Public Comments

CSB's Draft Tesoro Anacortes Refinery Investigation Report

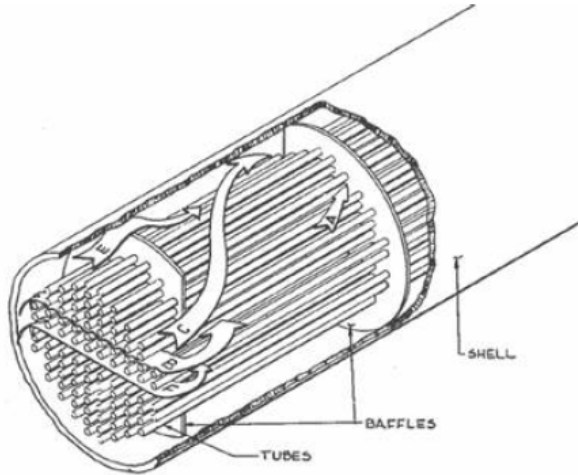
2	<p><u>Nelson Curve Development:</u></p> <p>While API standards are developed from empirical (experience-based) data, they are also supported by experimental data. In fact, to provide transparency for the development of the Nelson curves presented in Recommended Practice 941, Steels for Hydrogen Service at Elevated Temperatures and Pressures in Petroleum Refineries and Petrochemical Plants, there are 33 references contained in section 3.4.1, citing a variety of both API committee data references and publically available sources. And to provide further documentation and transparency, API published API Technical Report 941, The Technical Basis Document for API RP 941, a 300-page scientific report. This publication provides a comprehensive and detailed engineering review and analysis of the development of the Nelson curves, including the origin and pedigree of the base data used to develop and refine the curves.</p>	<p>While some of the reference data on the Nelson Curve graph (Figure 1) of API 941 are from experimental data, all of the data supporting the location of the carbon steel Nelson curve that are above 400 °F and below the current carbon steel curve, except for one paper based upon one company’s experience with HTHA, are labeled as “Private communications to API.” These data are all empirical, experienced-based observations by the party submitting the data. API acknowledges that this type of data can be unreliable. API TR 941 Section 17.0 states, “[W]e find it difficult to obtain accurate operating data and material damage assessments.”</p>

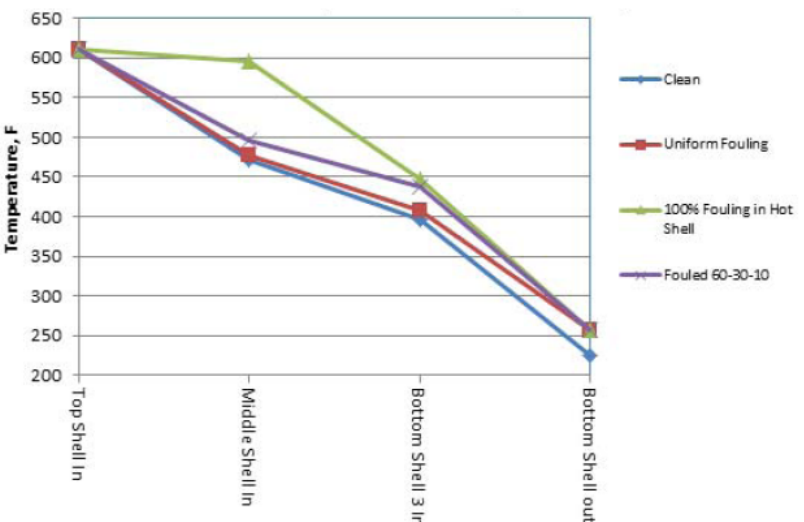
American Petroleum Institute (API) Comments	CSB Responses
8	<p>In fact, API’s standards facilitate the availability of proven, sound engineering and operating practices throughout the world. API’s standards are the most widely cited and used standards on a global basis for the oil and natural gas industry, as cited in the International Oil and Gas Producers Report No. 426, <i>Regulator’s Use of Standards</i>, March 2010. And, API standards are written in performance-based language to the maximum extent possible, which allows the users to make the best determination in how to apply the standard, given the variety of operating conditions at refineries and petrochemical plants. Mandating a “one-size fits all” approach could actually lead to less safe, rather than more safe operating conditions, as the use of API standards do not obviate the need to apply sound engineering judgment. In addition, under the OSHA Process Safety Management regulation, API’s mechanical integrity standards are acknowledged as Recognized and Generally Accepted Good Engineering Practice, or RAGAGEP, and OSHA cites 13 API standards in the U.S. Code of Federal Regulations. For more than 90 years, API has led the development of standards for the petroleum, petrochemical and natural gas industries. These documents, which currently number over 600, are developed under an American National Standards Institute (ANSI) accredited process, following ANSI’s essential requirements of openness, balance, consensus, and due process, and are updated on a regular basis. API standards are developed by committees made up of member and nonmember companies of API, including representatives of state and federal agencies. Furthermore, prior to final publication, API standards are available for public comment. It is because of this robust process that over 100 API standards are cited in U.S. Federal Regulations.</p>	<p>The CSB agrees that API standards provide very valuable information to the petrochemical industry. However, the CSB has found in recent investigations that major process safety incidents as a result of metallurgical failures occur even when the company that experienced the incident complies fully with the applicable API standard. This suggests that these standards must have minimum requirements that would help to prevent such catastrophic incidents. The CSB understands that these minimum requirements would not be a “one-size fits all” approach. For instance, an analysis of inherently safer materials of construction for a vessel must take into account all applicable damage mechanisms and process conditions. However, such an analysis will often identify a material that can greatly reduce a vessel failure as a result of the applicable process damage mechanisms.</p>

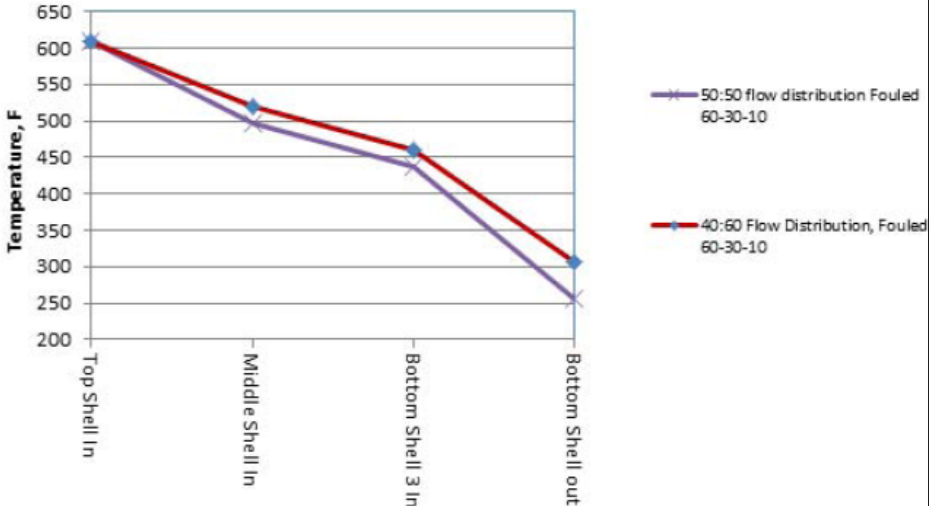
10	<p>Baffle-to-Shell Bypassing. Figure 25 on page 47 of the draft CSB report shows an operating range of the stainless steel clad portion of the carbon steel Naphtha Hydrotreater Unit (NHT) B/E exchangers. According to CSB calculations, the operating temperature range in that region extends well above the Nelson curve for carbon steel materials.</p> <p>All heat exchangers with removable tube bundles, such as those installed in the Anacortes refinery NHT unit, have a clearance of about ¼ inch (could be slightly less or more depending on the shell diameter). This clearance is necessary to accommodate tube bundle removal for cleaning and inspection. As shown in the sketch below, the baffle-to shell by-pass stream E is thermally not active because it is not in contact with the tube bundle containing the cooling fluid (NHT reactor feed).</p>	<p>There is a distance of 1.7 feet between the centerline of the shell-side inlet nozzle and the Can 3 / Can 4 weld seam that experienced HTHA. The CSB expects that heat transfer occurred in this length of the heat exchanger. In addition, there is only 7/80” (0.0875”) clearance between the O.D. of the baffles and the I.D. of the shell. Therefore, the baffle-to-shell bypass flow will be much less than if it had been ¼”.</p>

American Petroleum Institute (API) Comments	CSB Responses
	 <p>Consequently, shell temperature in the area of circumferential weld immediately downstream of the stainless steel clad portion of the B and E exchangers will correspond closely to the shell inlet temperature and the maximum operating temperatures for Can 4. For this reason, the operating range for the E exchanger, shown in Figure 26 on page 48, is not correct. Figure 26 should be revised to include the maximum operating temperatures shown in Figure 25, including the temperature range well above the carbon steel Nelson curve.</p>	
11	<p>The draft CSB report states that fouling in the heat exchangers has significant impact on the shell side temperatures and we strongly agree with this assessment. However, as shown in Figure 44 on page 133 of the draft CSB report, the sensitivity analysis on impact of fouling was one for a very narrow range of fouling conditions. Thermal analysis performed by CSB included fouling resistance in shells A/D (top hottest shells) between 50 and 60% of the total fouling resistance. Thermal conditions in NHT Unit preheat exchangers are such that all liquid feed is vaporized prior to entering the furnace. Full feed vaporization that takes place in the hot (top) shell results in heavy fouling conditions due to deposition of dissolved solids in the feed. The cold and intermediate shells experience very low fouling rates. The pictures below illustrate fouling distribution in one of API member company's</p>	<p>As discussed in the CSB's draft Tesoro report, the distribution of fouling chosen to model the Tesoro heat exchangers is based upon visual observations of fouling on the tube-side of the exchangers. These observations typically indicated light fouling on the tube-side of the C/F heat exchanger, moderate fouling on the tube-side of the B/E heat exchangers, and heavy fouling on the tube-side of the A/D heat exchangers. Tesoro never performed a fouling study prior to the</p>
